PLUG AND ABANDONMENT PROCEDURE

Lawson #1A

Re: Permanent Abandonment
Well: Lawson 1A

CONDITIONS OF APPROVAL

Current

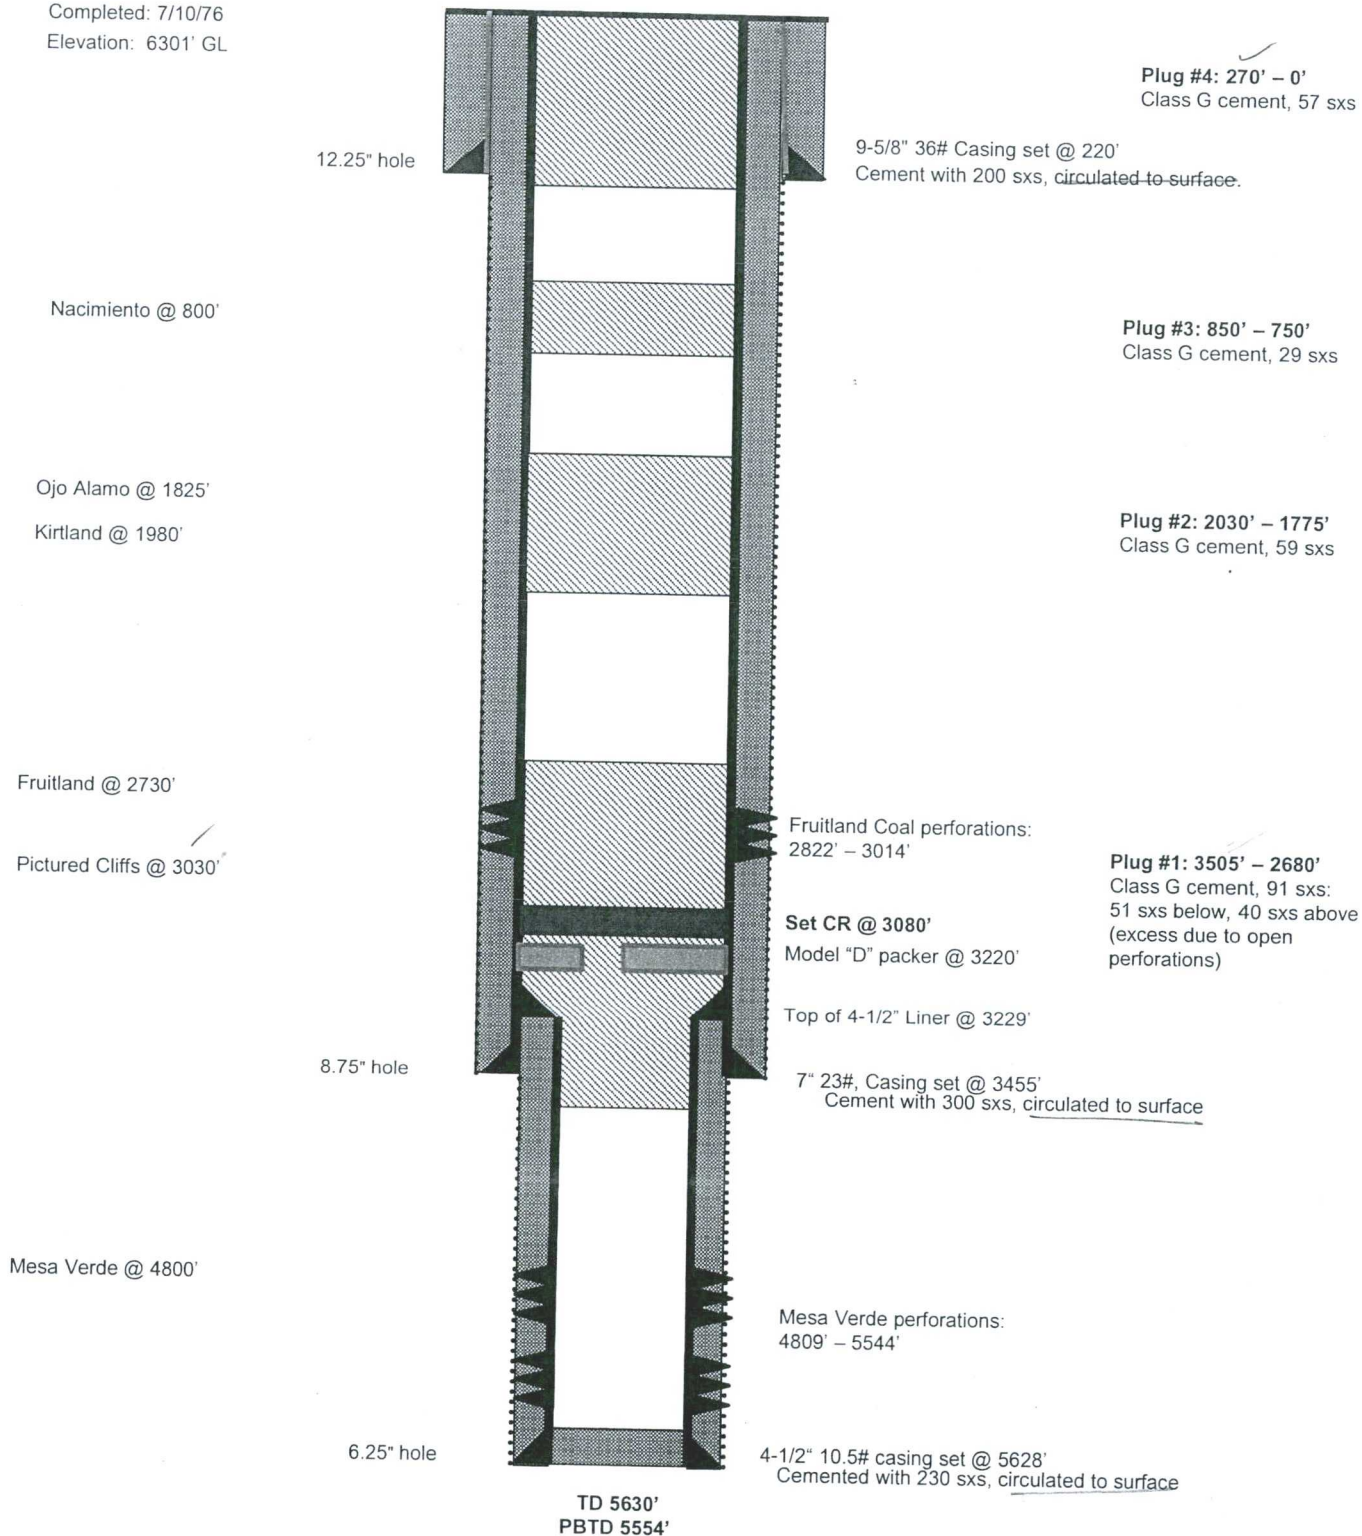
- Notify NMOCD 24hrs prior to beginning operations.
- Add perforation plug from 4759' - 4659'

1. Plugging operations authorized are subject to the attached "General Requirements for Permanent Abandonment of Wells on Federal and Indian Lease."
2. Farmington Office is to be notified at least 24 hours before the plugging operations commence (505) 564-7750.
3. The following modifications to your plugging program are to be made:
 - a) Set Plug 1 (3505 – 2650) ft. to cover the 7" casing shoe and the 4-1/2" liner, Pictured Cliffs, and Fruitland tops. BLM picks top of Fruitland at 2700 ft.
 - b) Set Plug 2 (2030 – 1760) ft. to cover the Kirtland and Ojo Alamo tops. BLM picks top of Kirtland at 1980 ft. BLM picks top of Ojo Alamo at 1810 ft.
 - c) Set Plug 3 (531 – 431) ft. to cover the Nacimiento top. BLM picks top of Nacimiento at 481 ft.
